Subject: DRIVER SIDE SEATBACK RECLINING POSITION CHANGES BY ITSELF WHEN CUSTOMER EXITS THE VEHICLE	Bulletin No: 09-020/13
	Last Issued: 09/05/2013

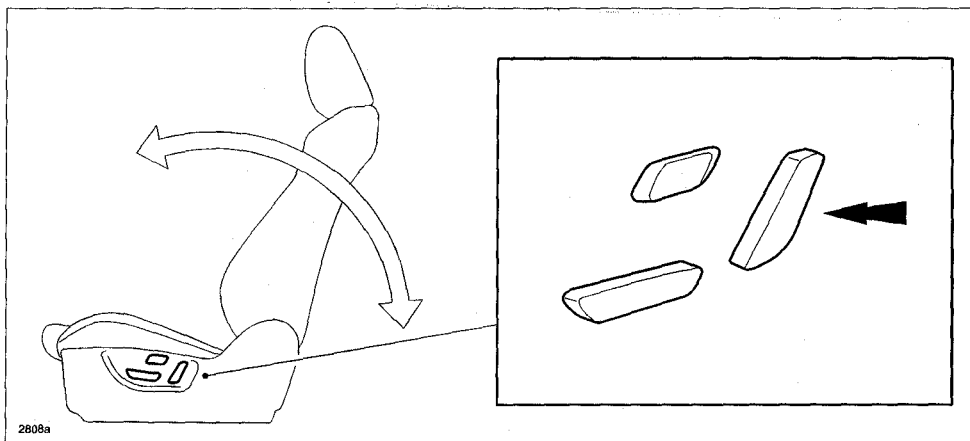
Some customers may complain that the driver side seatback reclining position seems to change by itself. This may be caused unknowingly by the customer when they exit the vehicle. The customer's leg may be contacting the recliner switch knob and changing the seatback reclining position.

The configuration of the recliner switch knob has been changed to eliminate this concern. Customers having this concern should have their vehicle repaired using the following repair procedure.

1. Verify the customer concern.
2. Replace the recliner switch knob with a modified new part according to the instructions on MS3 online or the Workshop Manual (section 09-13 FRONT SEAT SIDE COVER REMOVAL/INSTALLATION).
3. Verify the repair.
